March 30, 2012
NRC3-12-0011

Subject: Detroit Edison Company Submittal of Revised Site-Specific Soil-Structure Interaction Analyses

**COLA Markups Incorporating the
Revised Site-Specific SSI Analyses**
(following 70 pages)

The following markup represents how Detroit Edison intends to reflect these changes in the next submittal of the Fermi 3 COLA. However, the same COLA content may be impacted by responses to COLA RAIs, other COLA changes, plant design changes, editorial or typographical corrections, etc. As a result, the final COLA content that appears in a future submittal may be different than presented here.

Figure 3.7.2-201 SASSI2000 Plate Elements for RB/FB Basemat

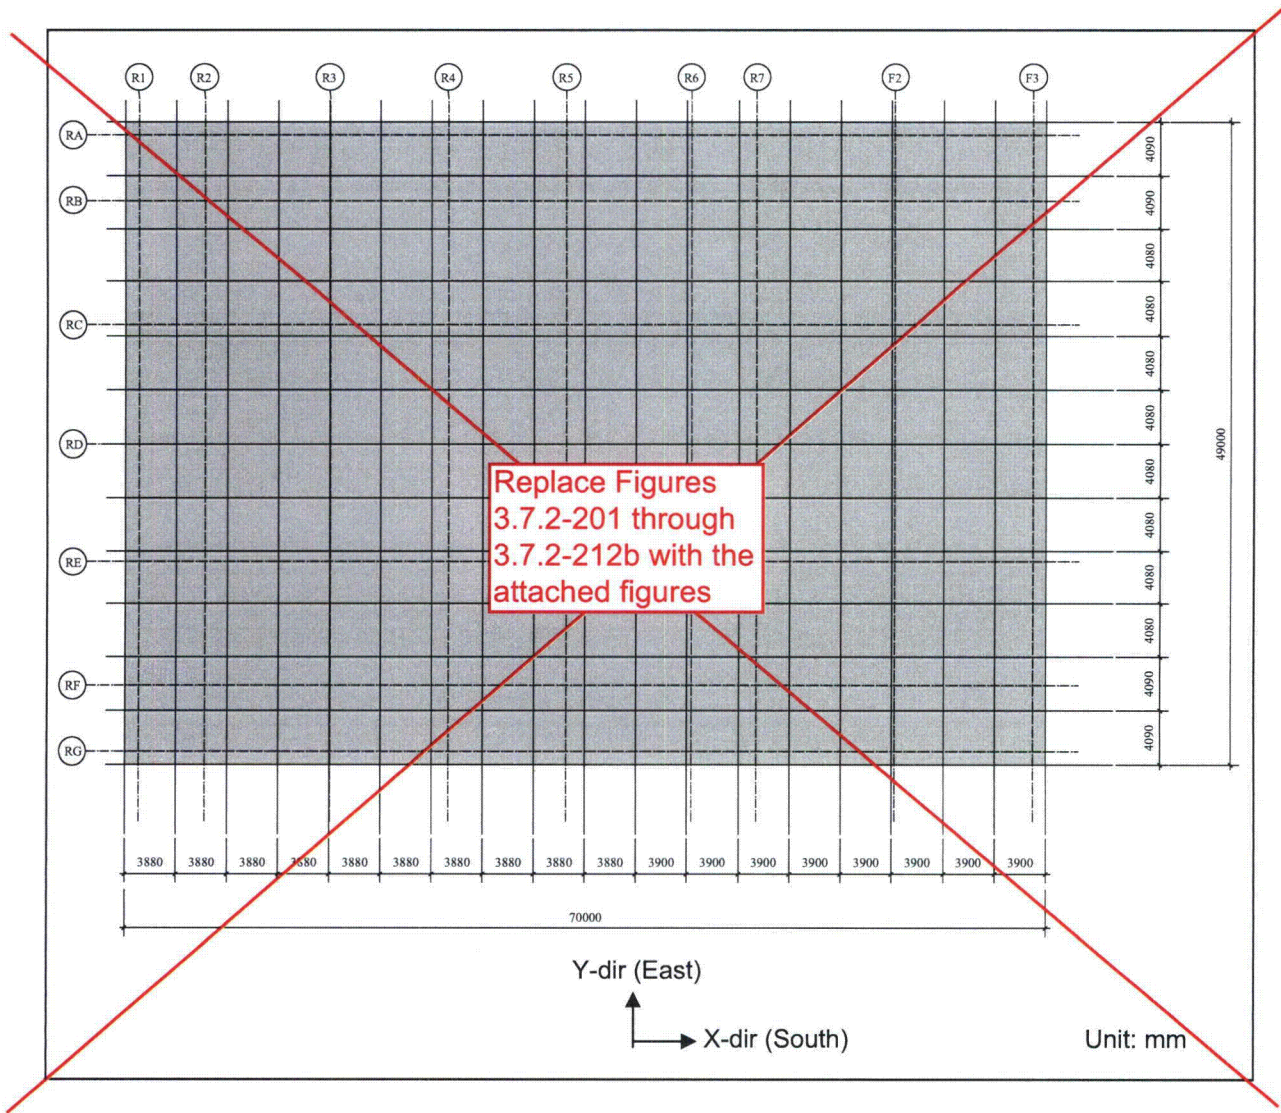
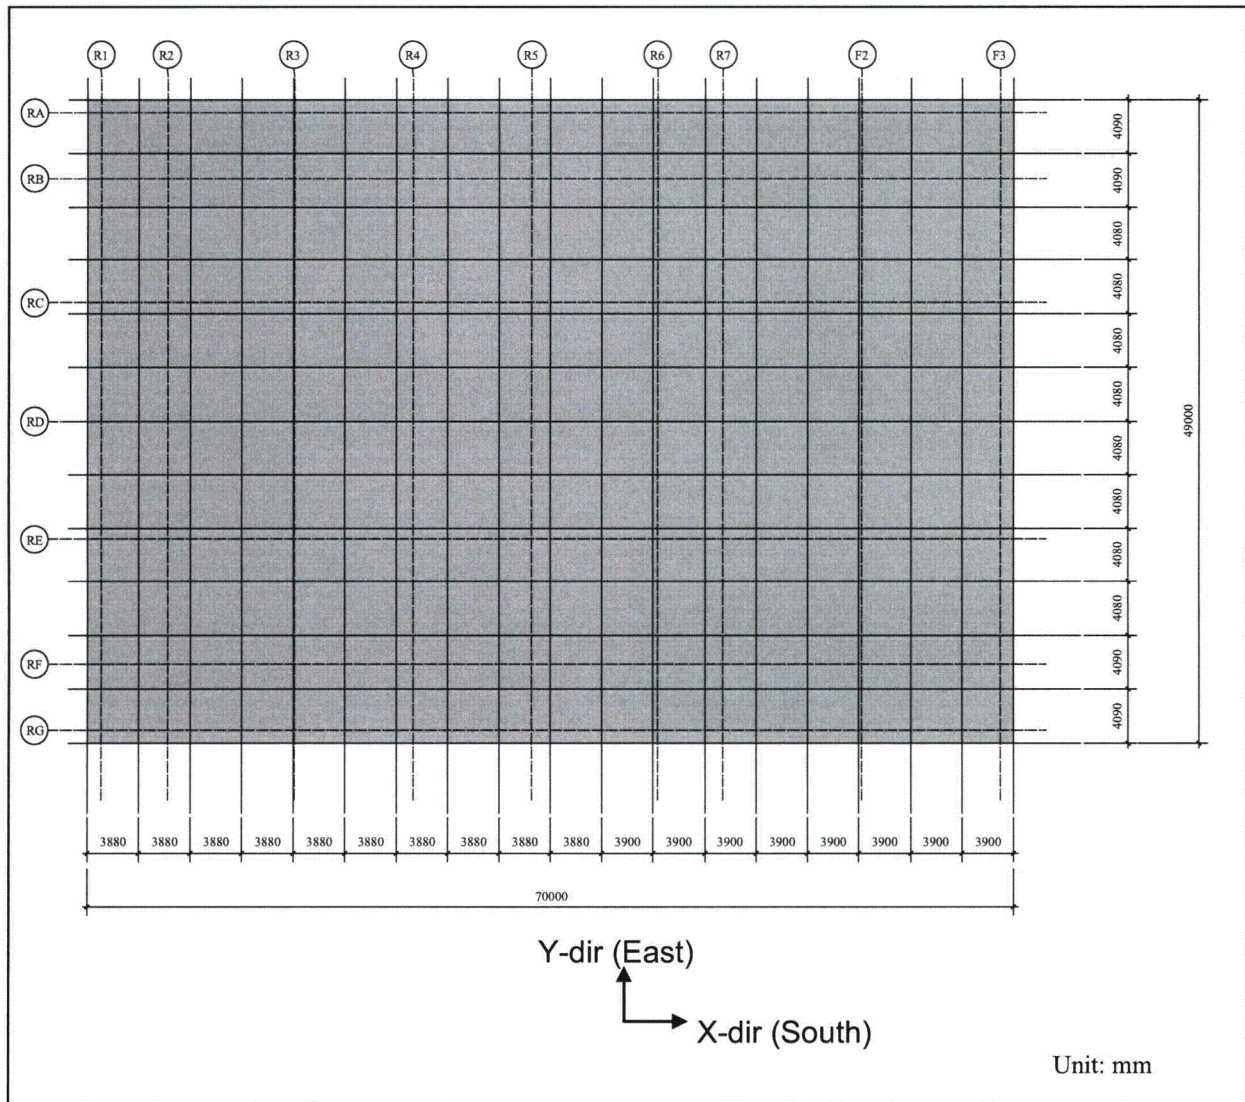
Figure 3.7.2-201 SASSI2000 Plate Element for RB/FB Basemat [EF3 SUP 3.7-4]
